Project	IEEE 802.16 Broadband Wireless Access Working Group < http://ieee802.org/16 >	
Title	Sleep Mode and Handoff corrections for Task Group e	
Date Submitted	2003-09-04	
Source(s)	<p>Itzik Kitroser Yigal Leiba Runcom Technologies Ltd. 2 Hachoma St. 75655 Rishon Lezion, Israel</p> <p>Ken Stanwood Ensemble Communications 9890 Towne Centre Dr San Diego, CA 92121</p>	<p>Voice: +972-3-9528440 Fax: +972-3-9528805 mailto:itzikk@runcom.co.il mailto:yigall@runcom.co.il</p> <p>Voice: +1 (858) 404-6559 Fax: +1 (858) 458-9860 mailto:ken@ensemble.com</p>
Re:	Task Group Review of IEEE 802.16e-03/07r3 IEEE 802.16 Task Group e	
Abstract	This document provide corrections per given actions points given at session #26	
Purpose		
Notice	This document has been prepared to assist IEEE 802.16. It is offered as a basis for discussion and is not binding on the contributing individual(s) or organization(s). The material in this document is subject to change in form and content after further study. The contributor(s) reserve(s) the right to add, amend or withdraw material contained herein.

Sleep Mode and Handoff corrections for Task Group e

This document contains modified text as per action points given

Figure 123a—SS Awaiting Sleep Response SDL Diagram

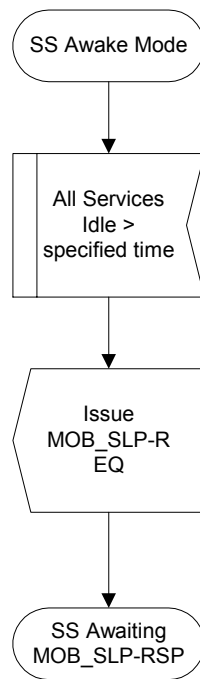
Figure 123a shows the SDL for the SS in the awake state.

Figure 123b—SS Sleep Mode SDL Diagram

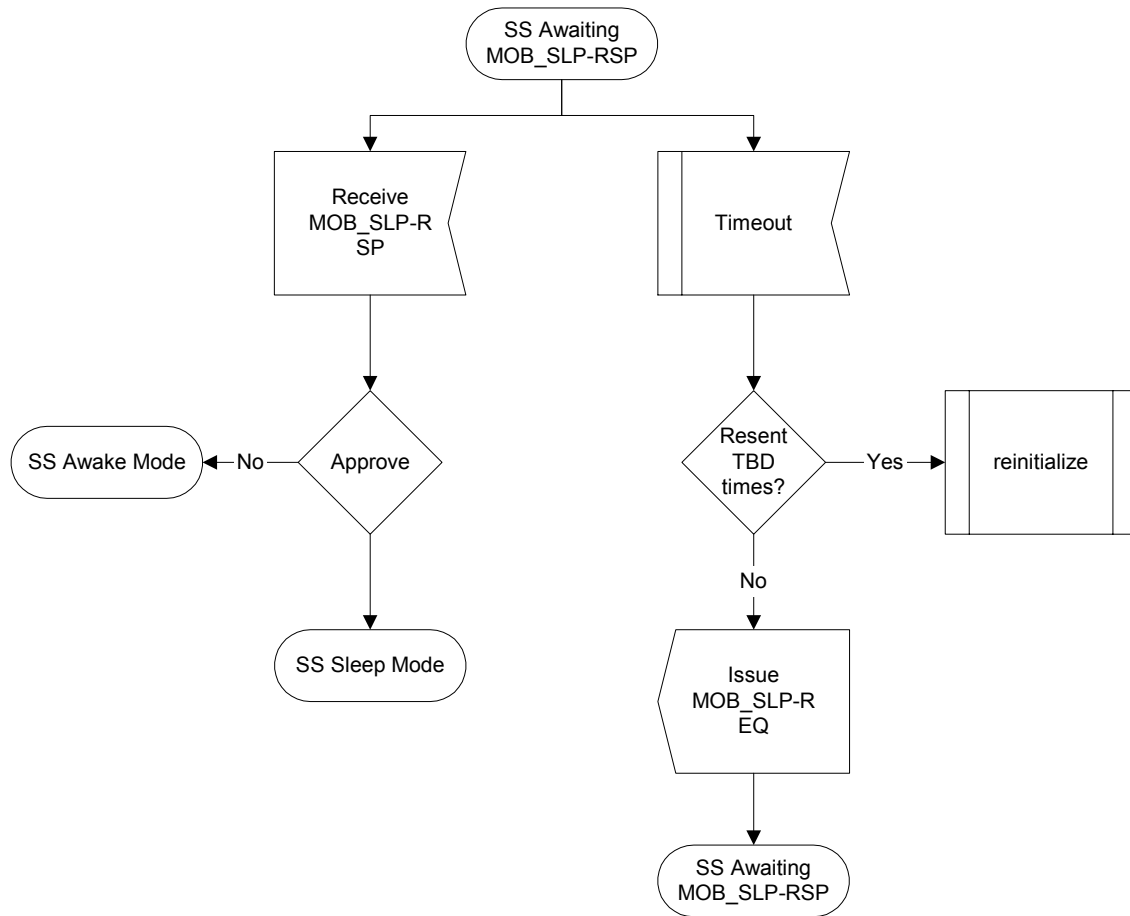
Figure 123b shows the SDL for the SS after it has sent an MOB_SLP-REQ message and is awaiting a response.

Figure 123c—SS Await Poll SDL Diagram

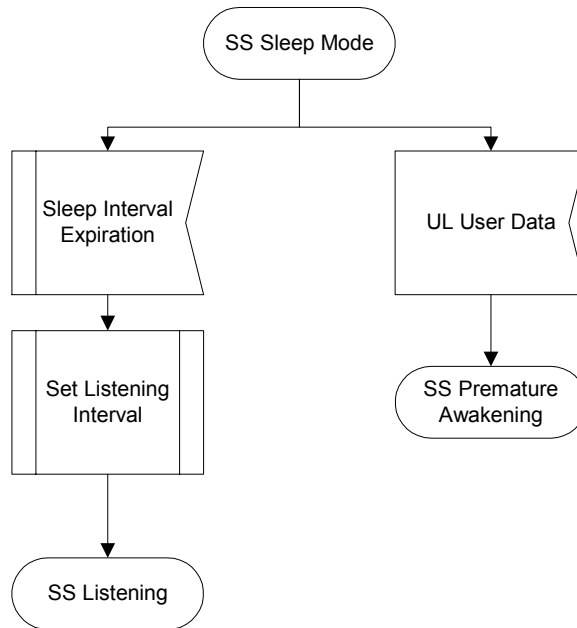
Figure 123c shows the SDL for the SS while in sleep-mode.

Figure 123d—SS Listening SDL Diagram

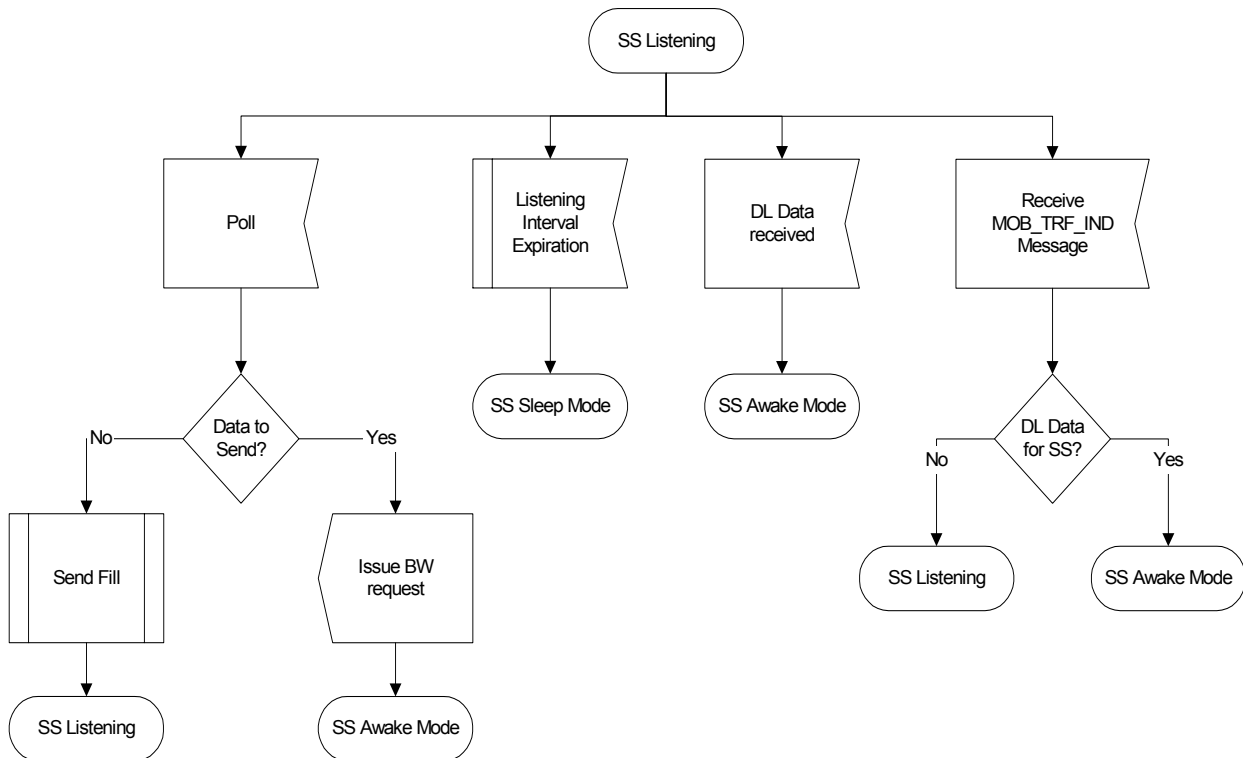
Figure 123d shows the SDL for when the SS is listening for an MOB_TRF-IND message from the BS.

Figure 123e—SS Premature Awakening SDL Diagram

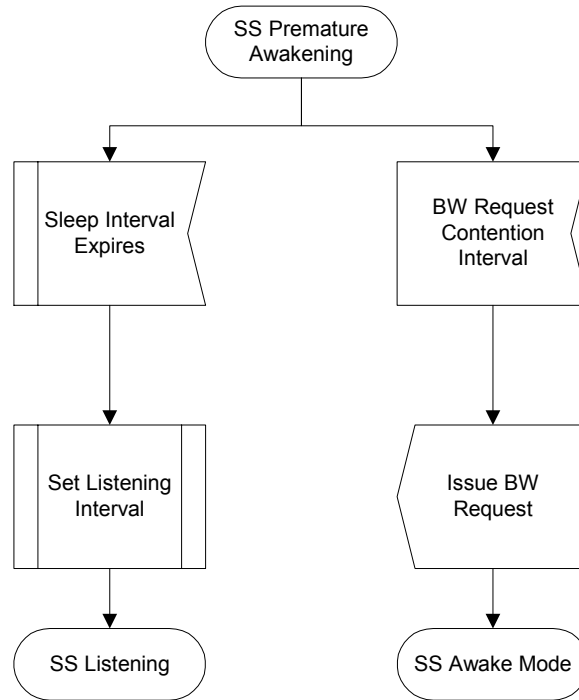
Figure 123e shows the SDL for when the SS has awakened prematurely.

Figure 123f—BS – SS Awake Mode SDL Diagram

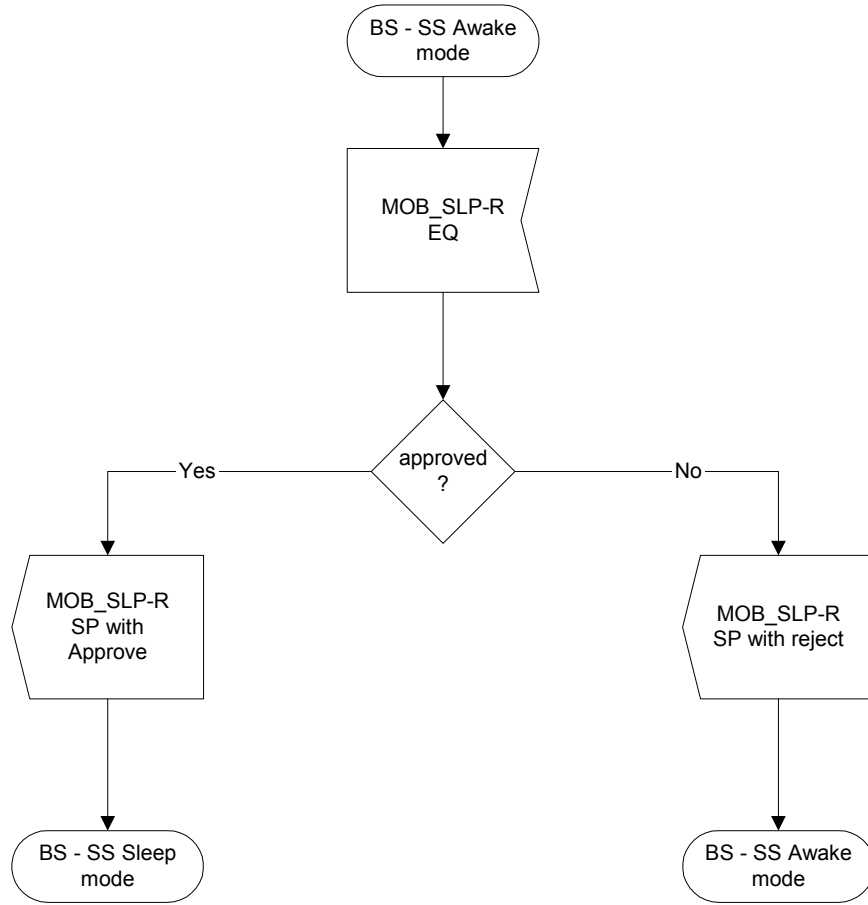
Figure 123f shows the SDL for the BS when an SS is in awake mode.

Figure 123g—BS – SS Sleep Mode SDL Diagram

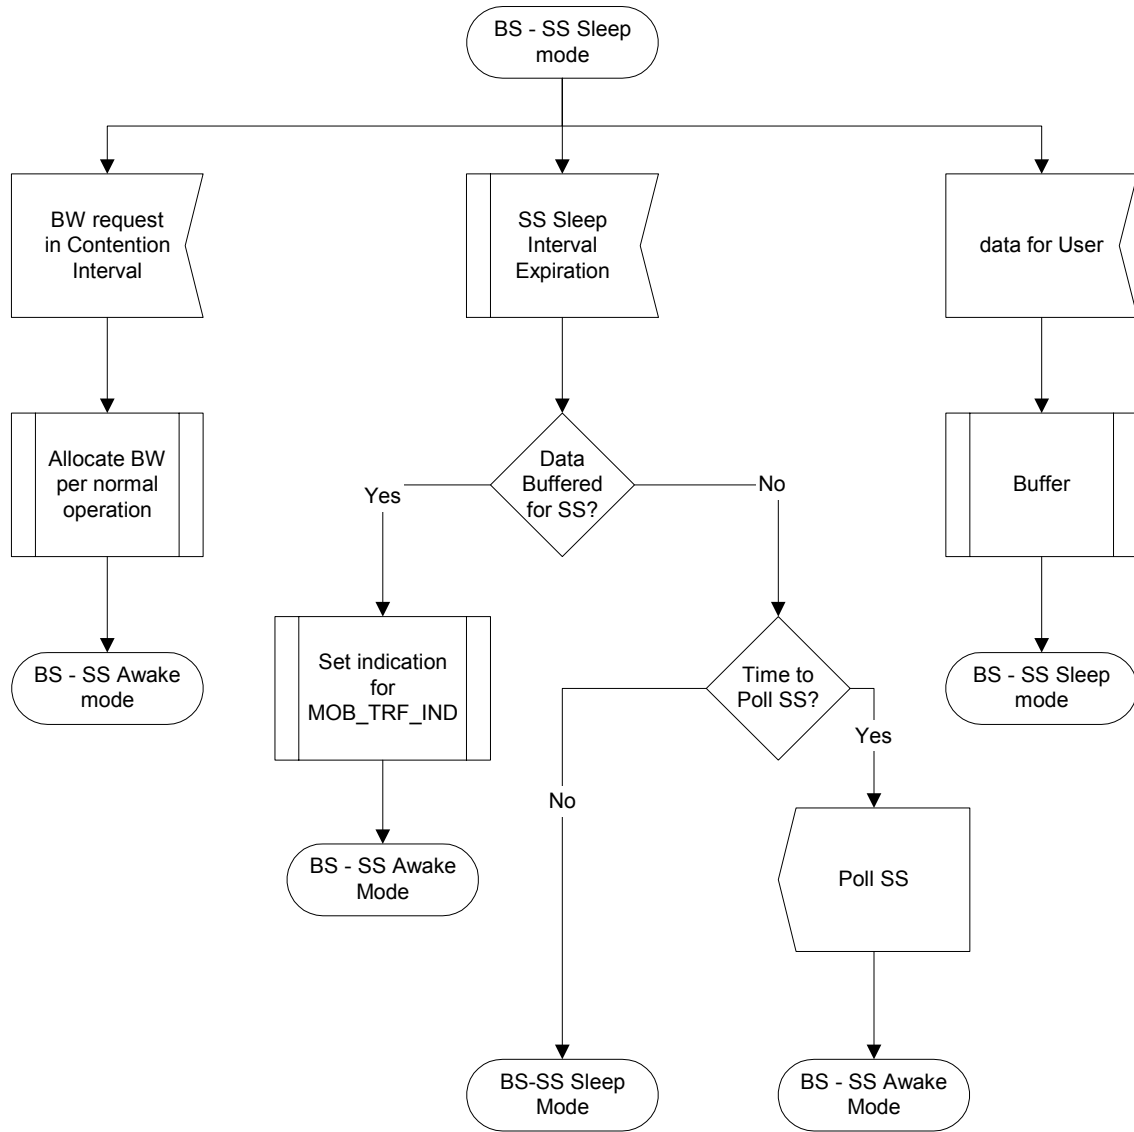
Figure 123g shows the SDL for the BS when the SS is in sleep mode.

Figure 123h—BS – SS Awakening SDL Diagram

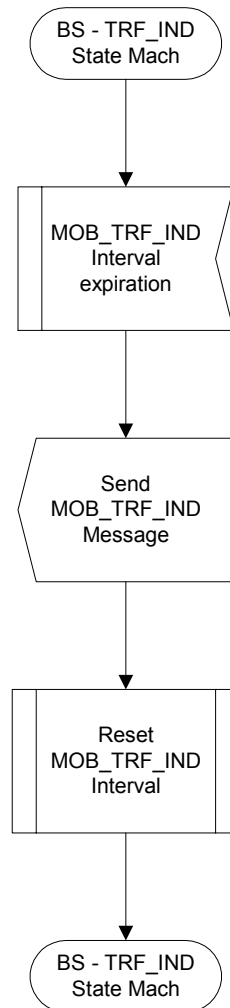
Figure 123h shows the BS SDL for when the SS is awakening.
